Stakeholder	Comment no.	Page no.	Section no.	Comment	EAG Response
Faculty of Intensive Care Medicine	1	21		Clinicians should use both creatinine and urine output to recognise AKI. The lag phase in creatinine rise appears a bit silly to the lay person if the patient is anuric21	On page 21, plain English summary, we state that "level of creatinine in the blood or urine is used by health professionals to decide whether AKI is present." This has now been modified to: "At present, the level of creatinine (a waste product filtered by the kidneys) in the blood and the urine output are used by health professionals to decide whether AKI is present" (see Erratum).
Faculty of Intensive Care Medicine	2	21		Studies are mainly non-uk: true. But also the ICU criteria may be different when compared to the UK. (As noted on page 43)	No response required.
Faculty of Intensive Care Medicine	3	23		"The remit of this work was to evaluate the clinical and cost effectiveness of biomarker use in the evaluation of patients not in critical care, but who might be considered for admission to critical care." This is a slightly odd remit given that most of the studies utilised these tests in patients already on

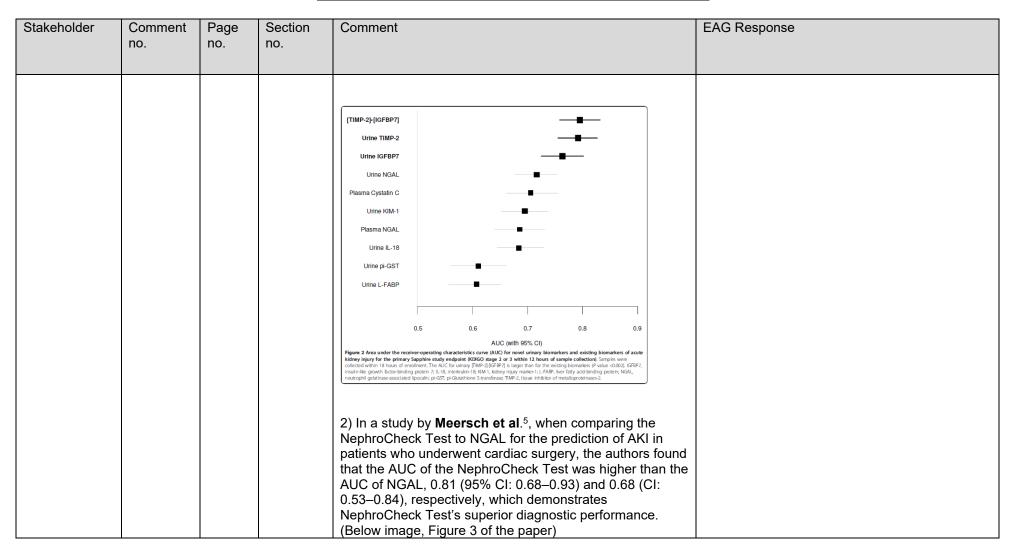
Comment no.	Page no.	Section no.	Comment	EAG Response
			from Hall et al.² report (acknowledged in the last paragraph of Page 201 of DAR). This correction will also reduce the heterogeneity between NephroCheck studies and potentially reduce the propagated uncertainty in the economic model. Comment 1.B Description of the comment We reviewed the original paper by Di Leo et al.² and noticed that there is a discrepancy between the extracted sensitivity and specificity in DAR (Table 5, Page 77) and the corresponding numbers reported in Di Leo et al. Specifically, Table 5 shows the extracted Sensitivity and Specificity of NephroCheck are 0.56 and 0.54, respectively; however, the sensitivity and specificity numbers in the original report of the Di Leo et al. are 0.64 and 0.56, respectively. (Below image, page 273 of the paper) Additionally, the cut-off used in the Di Leo paper was 0.37 (not 0.3), which might slightly underestimate the sensitivity of NephroCheck.	Comment 1.B The accuracy data from the Di Leo et al.'s study was extracted and used correctly in the analyses (see forest plot on page 79). The typographical error in Table 5 has now been amended (see Erratum document). In line with the position of the authors of the paper (Di Leo et al.), we considered the cut-off of 0.37 akin to the NephroCheck validation value and decided to include the study in the meta-analysis. No further revision is required.

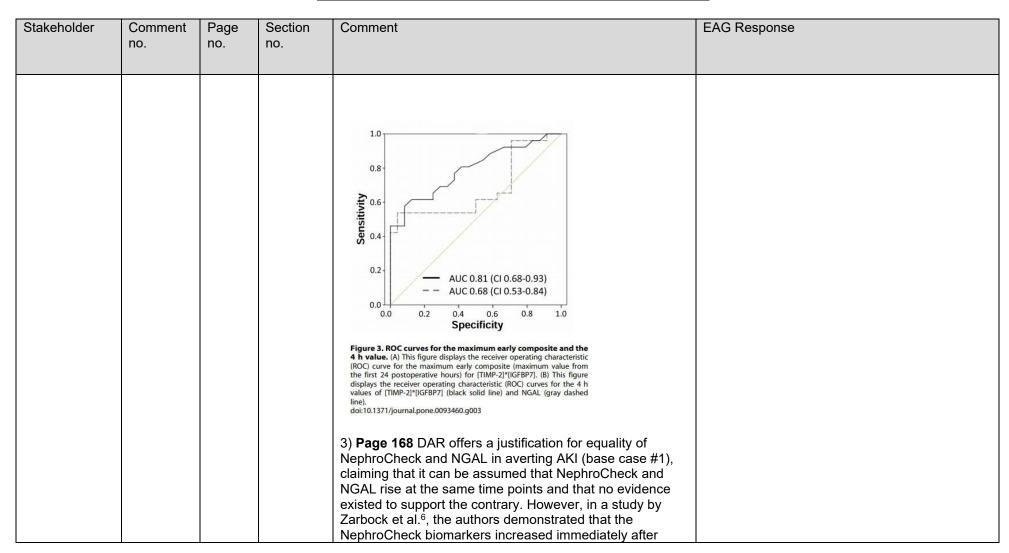
Stakeholder	Comment no.	Page no.	Section no.	Comment	EAG Response
				The optimal NC cutoff for our population is 0.37, and it was calculated minimizing the distance between the PROC plot and point (0.1; Fig. 3). AUC was 0.633, Specificity and Sensitivity were 56 and 64%, respectively, demonstrating that the NC test captured the majority of the AKI (positive) cases and a high number who did not manifest AKI. The number of False Positive was 209 (29%) with 86 False Negative. The confusion matrix on Table 2 have	
				To replace the sensitivity and specificity estimates extracted from Di Leo et al. with the correct numbers estimated in the paper. Specifically, the extracted sensitivity should increase from 0.56 to 0.64 and specificity should increase from 0.54 to 0.56. Similar to Problem 1A, this change needs to be applied throughout the report, including the meta-analysis and the cost-effectiveness model.

Result of amended model or expected impact on the results	
				Similar to Problem 1A, we suggest rerunning the meta- analysis and subsequently rerunning all the models that include pooled estimate of NephroCheck sensitivity and specificity using the updated input from Di Leo et al. We expect to see a pooled estimate that is more aligned with the totality of the literature on NephroCheck's diagnostic
